FORT VALLEY UTILITY COMMISSION

ADDENDUM NO. 1 REQUEST FOR PROPOSALS FOR FORT VALLEY WASTEWATER TREATMENT PLANT EFFLUENT PIPE CONSTRUCTION

Owner: Fort Valley Utility Commission
Date of Addendum: July 8, 2026
RFP Due Date: July 9, 2026
Revised Due Date July 24, 2026 (This Addendum)

FORT VALLEY UTILITY COMMISSION EXHIBIT A — PROJECT LOCATION MAP

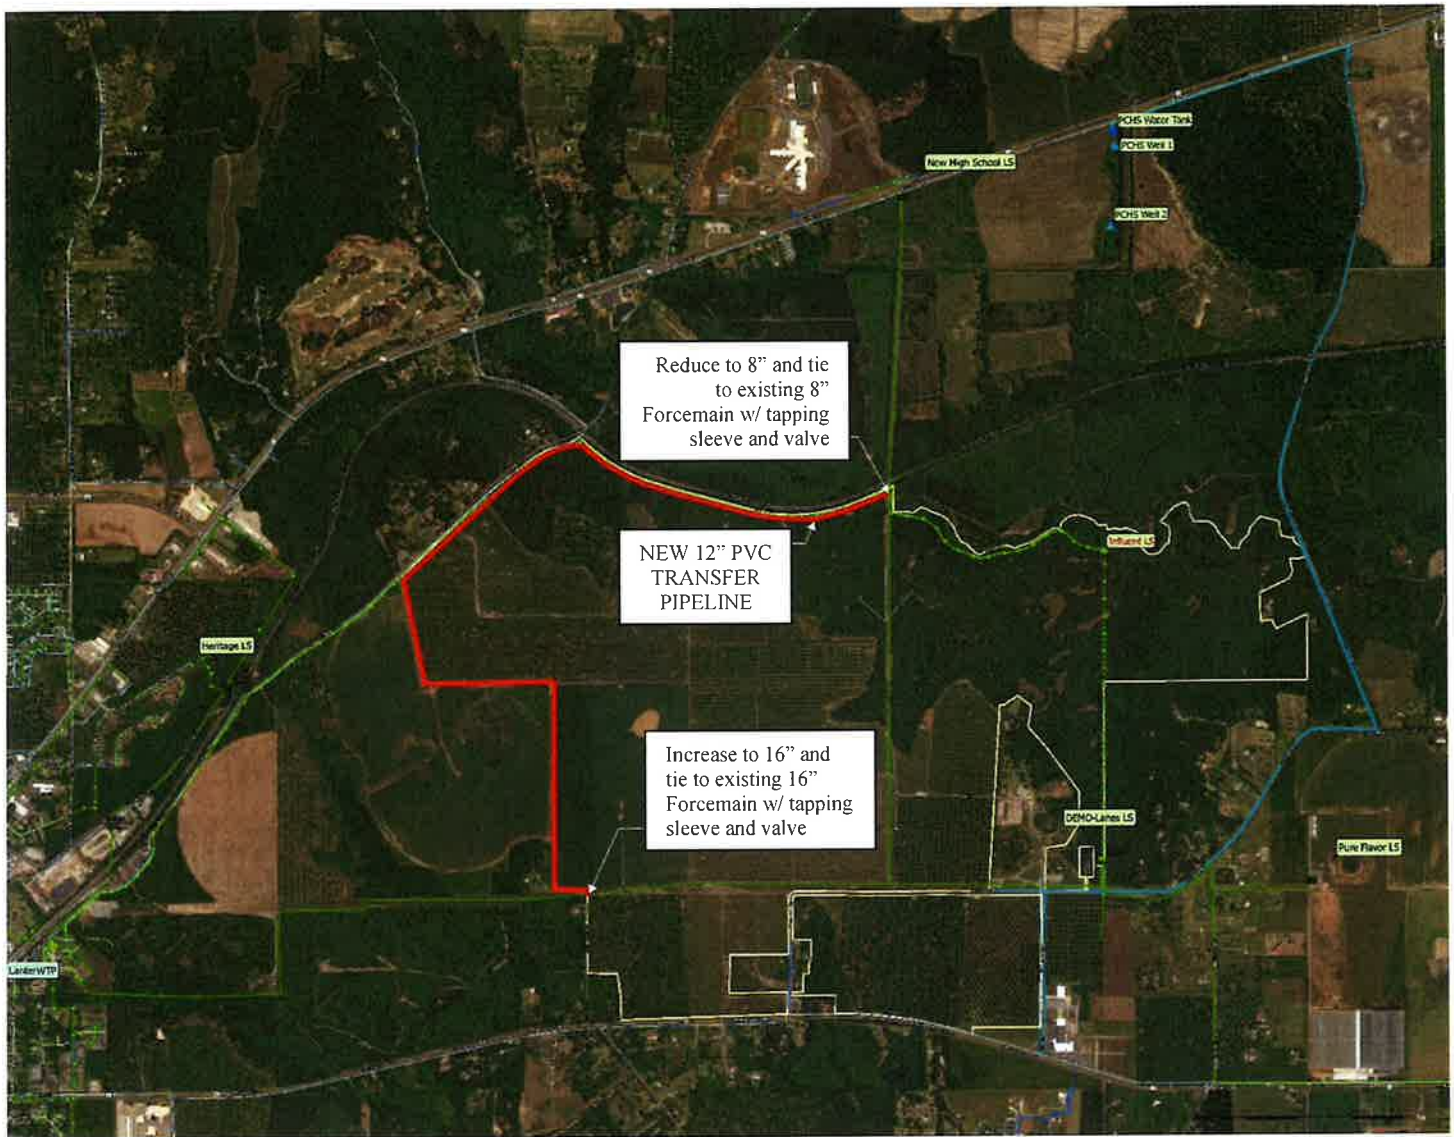
SCOPE ADDITION: The scope of work is revised to add the design and construction of **15,000 linear feet (LF) of 12-inch PVC transfer pipe (Force Main)**. Pipe material shall be either **Fusible PVC** or **C900 PVC Pressure Pipe (DR 18)** at the Proposer's discretion and as supported by the Proposer's design approach. Both pipe types are considered acceptable for all project scopes. Proposers shall clearly identify the pipe material selected in their technical proposal and provide justification for the selection based on constructability, hydraulics, and project conditions.

See **Exhibit A in this addendum— Project Location Map** (attached) for the approximate alignment of the new transfer pipe.

Note: Map depicts the approximate alignment of the new 12" transfer pipeline; PVC, C900 DR18 (shown in red). Alignment is conceptual and subject to final design.
